PROPOSED TECHNICAL SPECIFICATIONS

CPC IMPROVEMENT PROGRAM TECHNICAL SPECIFICATION CHANGES

DESCRIPTION OF AMENDMENT REQUEST

Figure 3.2-1 Allowable Peak Linear Heat Rate vs Burnup (COLSS out of service)

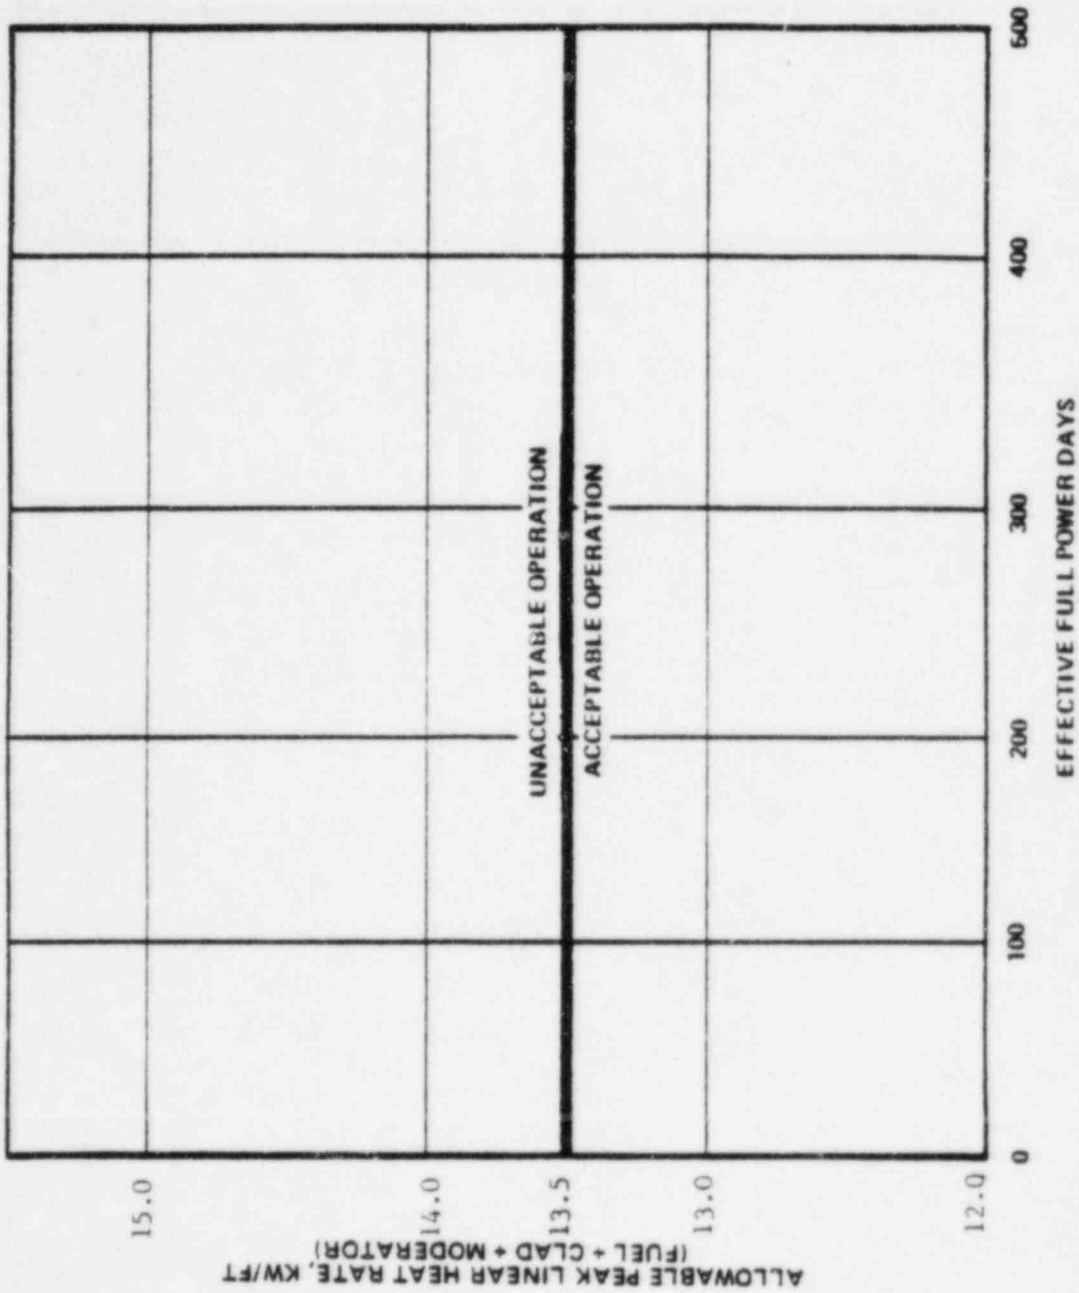
2. 3/4.2.1 & Basis	Revise format	Provide clear and consistent COLSS and COLSS-out-of-service monitoring, action and surveillance requirements.
3. 3/4.2.4 & Basis 3.3.1 Table 3.3-1 Actions 5.a & b	Revise format	Provide clear and consistent COLSS, COLSS-out-of-service and CEAC inoperable monitoring, action and surveillance requirements.
	Update figures for COLSS out of service monitoring	Consistent with revised format and CIP methodology and results.

2. This proposed change will revise the format of Technical Specification 3/4.2.1, "Linear Heat Rate," and the associated Bases, to provide clear and consistent monitoring, action and surveillance requirements when the Core Operating Limits Supervisory System (COLSS) is available or out of service. Technical Specification 3/4.2.1, "Linear Heat Rate" requires that the linear heat rate limit be maintained by operating within the region of acceptable operation as indicated by either the COLSS or the CPC.

2. This proposed change replaces the existing Figure 3.2-1 with words to the same effect, revises existing Figure 3.2-2 and makes it the new Figure 3.2-1 and also revises the existing Limiting Conditions for Operation (LCO), Surveillance Requirements and associated Bases of 3/4.2.1 to provide clear and consistent monitoring, action and surveillance requirements. This modification is similar to Example (i) of 48 FR 14870 in that it relates to a purely administrative change to the Technical Specifications. Replacement of a Figure with words to the same effect and revisions of the LCO, Action and Surveillance Requirements will be made to clarify the requirements. The proposed change pertains to a revision of a graphic representation of the LCO with a set of plain administrative control statements easy for understanding. The reduction of the linear heat rate limit value of the new Figure 3.2-1 is similar to Example (ii) in that it constitutes an additional limitation, restriction or control not presently included in the Technical Specifications.

- a. Maintaining COLSS calculated core power less than or equal to COLSS calculated core power operating limit based on linear heat rate (when COLSS is in service); or
- b. Operating within the region of acceptable operation of Figure 3.2-1 using any operable CPC Channel (when COLSS is out of service).

4.2.1.2 The linear heat rate shall be determined to be within its limits when THERMAL POWER is above 20% of RATED THERMAL POWER by continuously monitoring the core power distribution with the Core Operating Limit Supervisory System (COLSS) or, with the COLSS out of service, by verifying at least once per 2 hours that the linear heat rate, as indicated on any OPERABLE CPC channel, is within the limit shown on Figure 3.2-1.

FIGURE 3.2-2

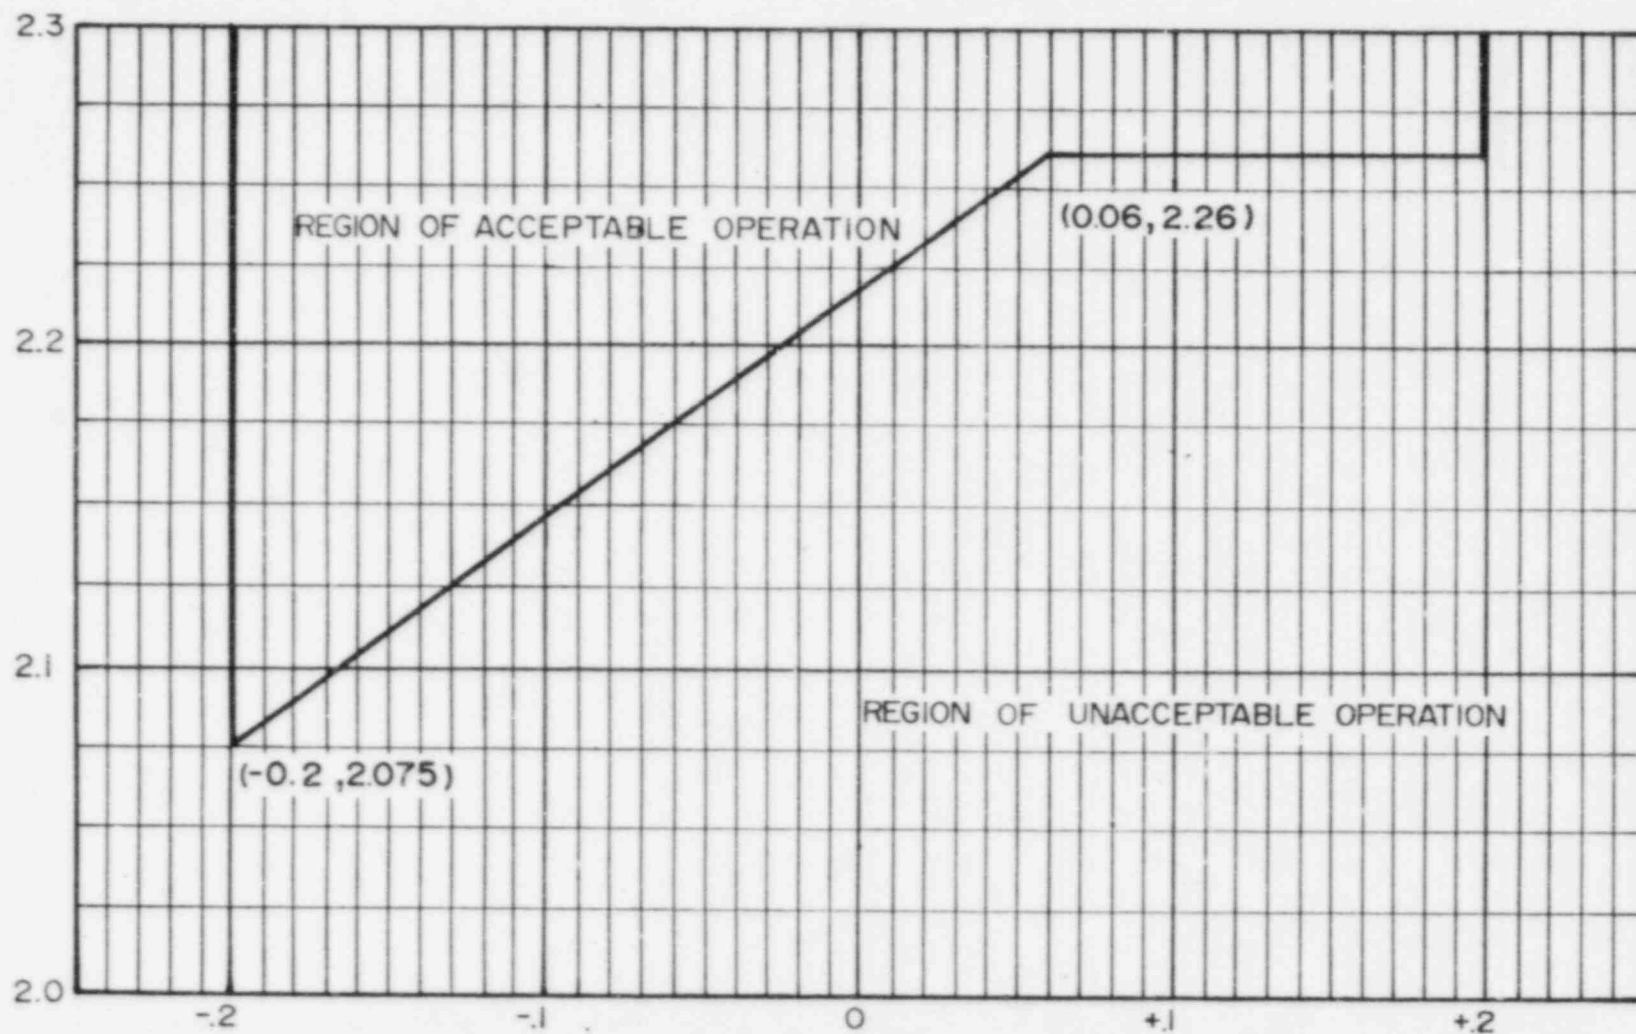
3.2.4.c states that when COLSS is out of service and at least one CEAC is operable, CPC calculated DNBR on any operable channel must be kept within the limits of the new Figure 3.2-2, which is identical to the old Figure 3.2-4. Section 3.2.4.d states that when COLSS is out of service and neither CEAC is operable, CPC calculated DNBR on any operable channel must be kept within the limits of Figure 3.2-3. The new Figure 3.2-3 is a power independent figure similar to the new Figure 3.2-2, but it accommodates the increased margin required when both CEACs are inoperable. The proposed change to Technical Specification 3.2.4 also modifies the existing action statement to be more clear and consistent with the LCO as described above. Also, Surveillance Requirement 4.2.4.2 is revised to allow use of any operable CPC channel for monitoring the DNBR with COLSS out of service. This proposed change recognizes that it is acceptable to monitor any one channel for control purposes during steady state operation. It is not necessary that the monitored channel be the most limiting since appropriate uncertainty allowances are already implemented in the CPCS calculations and trip setpoints. The CPCS continues to provide the required protection during transient operation.

3. The proposed change described in (a) revises Figures 3.2-3 and 3.2-4, replaces the existing LCO with four parts, i.e., Sections 3.2.4.a through 3.2.4.d, and also revises the related Surveillance Requirements and associated Bases to provide clear and consistent monitoring, action and surveillance requirements. This modification is similar to Example (i) of 48 FR 14870 in that it relates to a purely administrative change to Technical Specifications by imposing four applicable administrative control methods and two new Figures in lieu of two existing Figures to maintain an adequate DNBR margin under different states of plant operations. 3.2.4.a and 3.2.4.b replace the existing Figure 3.2-1 with words to the same effect when COLSS is in service. Additionally, both new Figures supplant the existing Figure 3.2-4 for compliance with 3.2.4.c and 3.2.4.d when COLSS is out of service. Thus, DNBR will be maintained by 3.2.4.a (or 3.2.4.c) when at least one CEAC is operable, and by 3.2.4.b (or 3.2.4.d) when neither CEAC is operable. Since the proposed change pertains to a revision of graphic representations of an LCO with a set of plain administrative control statements for easy understanding and two consolidated figures for simplification, it is a change within the scope contemplated by Example (i). This change may also be considered similar to

- 3.2.4 The DNBR limit shall be maintained by one of the following methods:
- a. Maintaining COLSS calculated core power less than or equal to COLSS calculated core power operating limit based on DNBR (when COLSS is in service, and at least one CEAC is operable); or
 - b. Maintaining COLSS calculated core power less than or equal to COLSS calculated core power operating limit based on DNBR decreased by 13.0% (when COLSS is in service and neither CEAC is operable); or
 - c. Operating within the region of acceptable operation of Figure 3.2-2 using any operable CPC channel (when COLSS is out of service and at least one CEAC is operable); or
 - d. Operating within the region of acceptable operation of Figure 3.2-3 using any operable CPC channel (when COLSS is out of service and neither CEAC is operable).

4.2.4.2 The DNBR shall be determined to be within its limits when THERMAL POWER is above 20% of RATED THERMAL POWER by continuously monitoring the core power distribution with the Core Operating Limit Supervisory System (COLSS) or, with the COLSS out of service, by verifying at least once per 2 hours that the DNBR, as indicated on any OPERABLE CPC channel, is within the limit shown on Figures 3.2-2 or 3.2-3, as applicable.

FIGURE 3.2-3
DNBR MARGIN OPERATING LIMIT BASED ON CORE PROTECTION CALCULATORS
(COLSS OUT OF SERVICE, BOTH CEACS INOPERABLE)

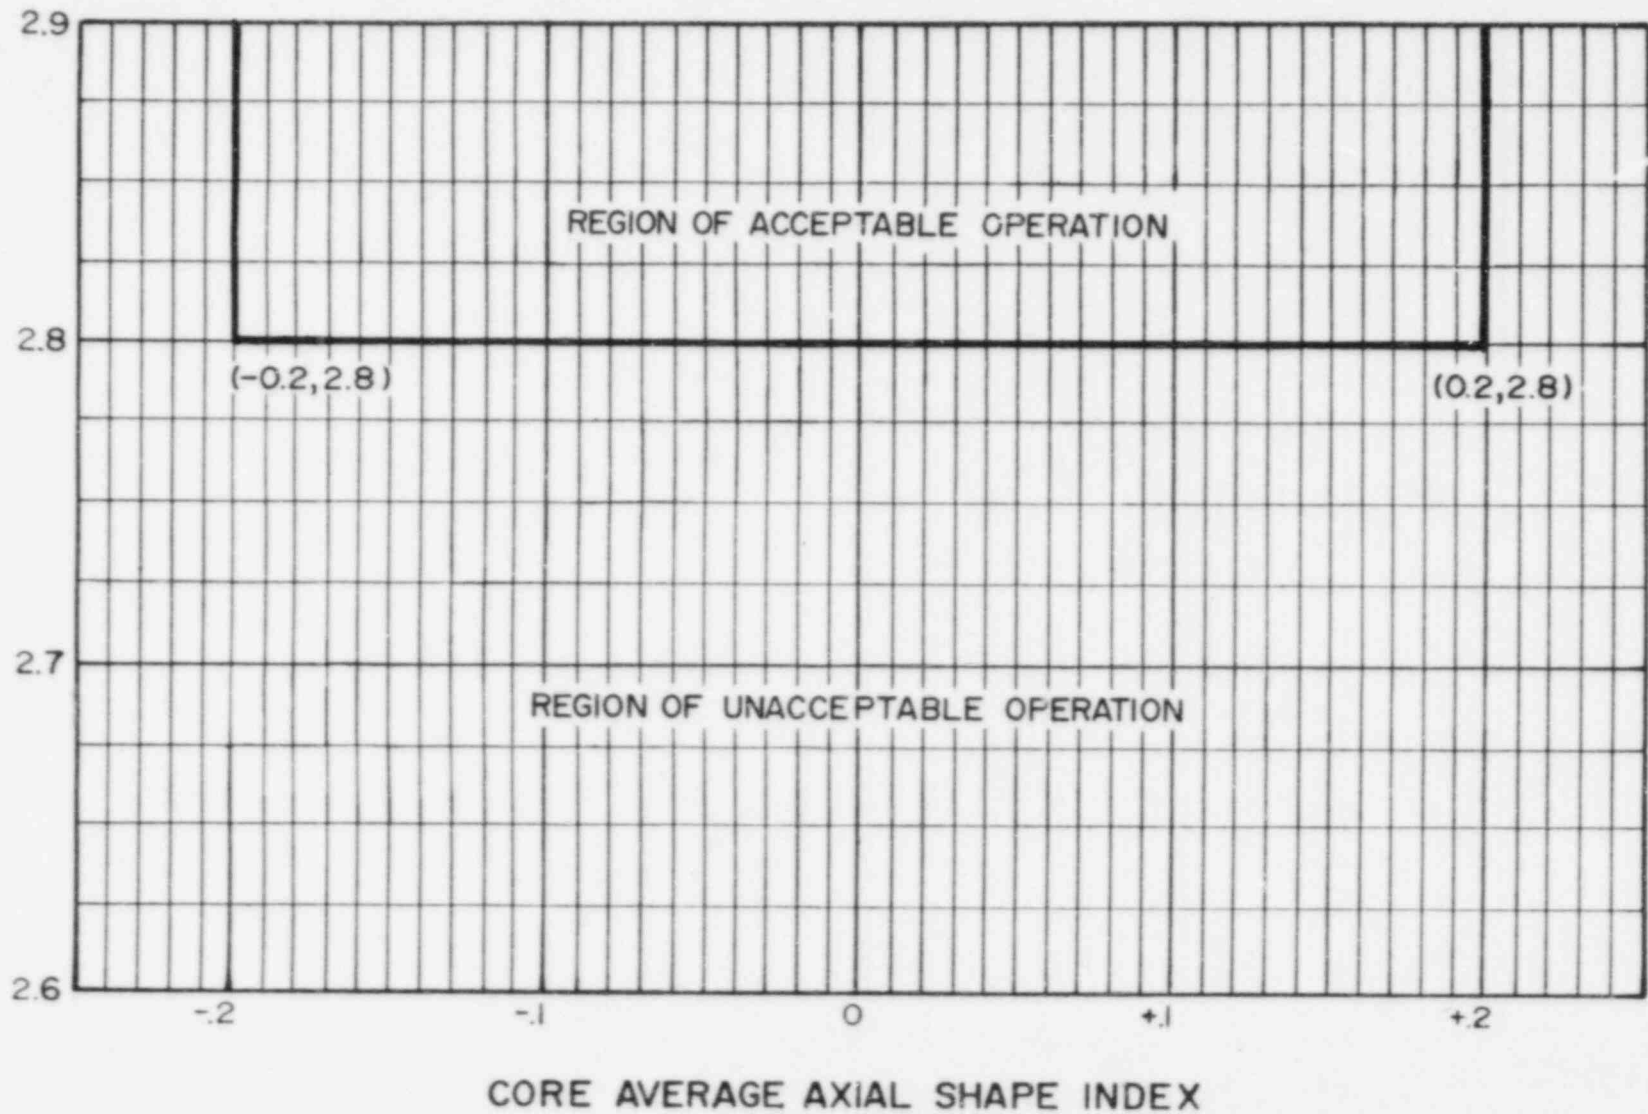
Example (ii) in that the addition of the new Figure 3.2-3 constitutes an additional operating restricting, not presently included in the Technical Specifications, for monitoring DNBR with COLSS and both CEACs out of service.

Parameters required to maintain the margin to DNB and total core power are also monitored by the CPCs. Therefore, in the event that the COLSS is not being used, operation within the limits of Figure 3.2-2 for CEAC operable or Figure 3.2-3 for both CEACs inoperable can be maintained by utilizing a predetermined DNBR as a function of AXIAL SHAPE INDEX and by monitoring the CPC trip channels. The above listed uncertainty and penalty factors are also included in the CPC.

FIGURE 3.3-1

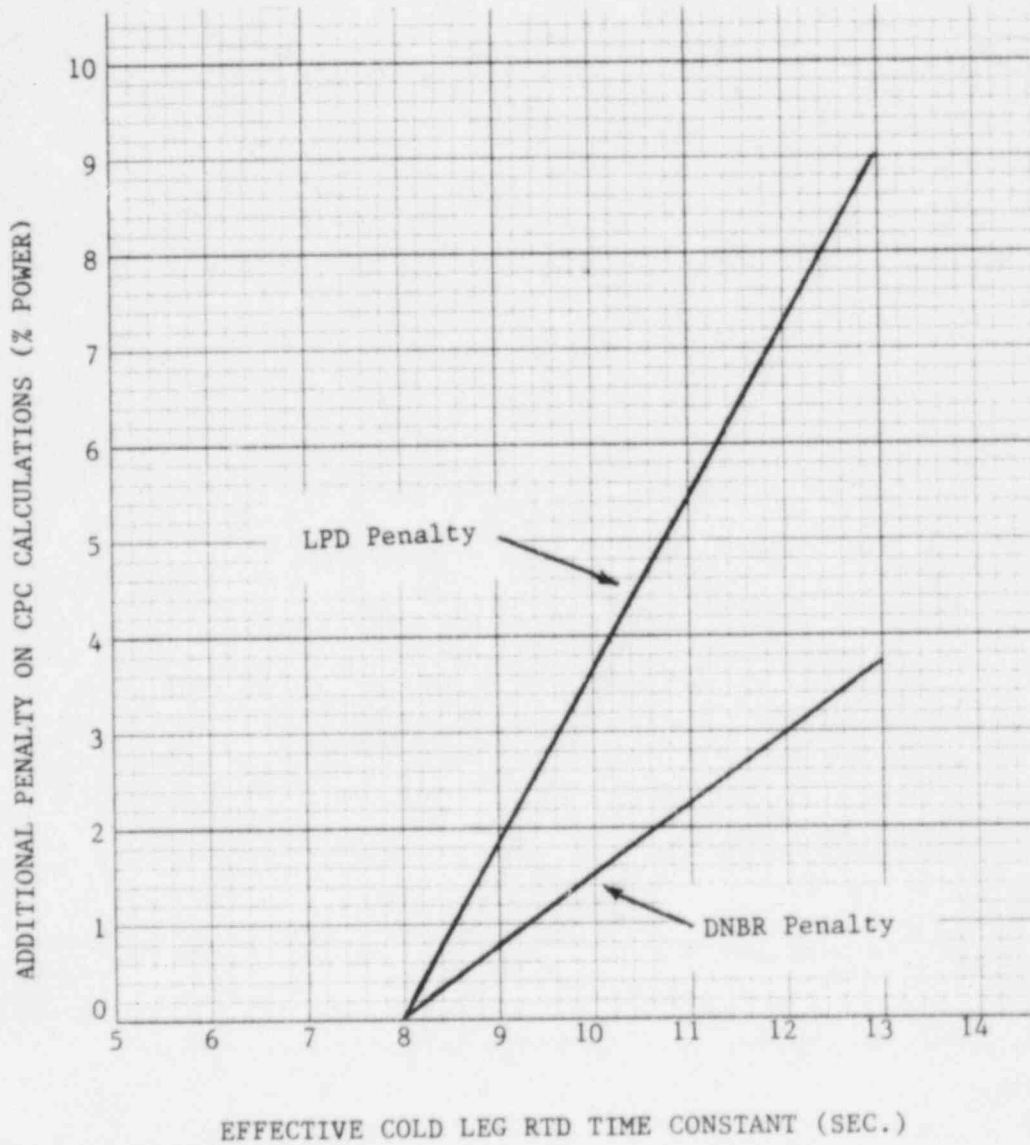
4. 3.3.1 Tables 3.3-2 and 3.3-3	Revised note to change RTD response time to 8 seconds for cold leg, 13 seconds for hot leg.	CIP dynamic compensation algorithms and constants assume 8 seconds for cold leg, 13 seconds for hot leg.
	Revise Figure 3.3-1 and Table 3.3-3.	Consistent with CPC revision and transient analysis assumptions and results.

A new Note ### is appended to item 10.d, "Hot Leg Temperature," to reflect the allowable hot leg RTD response time of 13.0 seconds. Figure 3.3-1 is revised accordingly, and Table 3.3-3 is deleted since the analyses assumes longer response times and adjustments are no longer needed for RTD response times \leq 13.0 seconds. Also, the definition of RTD response time is moved from Table 3.3-2 to a more appropriate location in the related Bases, and the Bases will be modified to reflect the revised RTD response times.

##Based on an effective resistance temperature detector (RTD) response time of < 8.0 seconds. If the effective RTD time constant for a CPC channel exceeds 8.0 seconds, the DNBR and LPD penalties for the affected channel(s) shall be increased by the amount indicated on Figure 3.3-1.
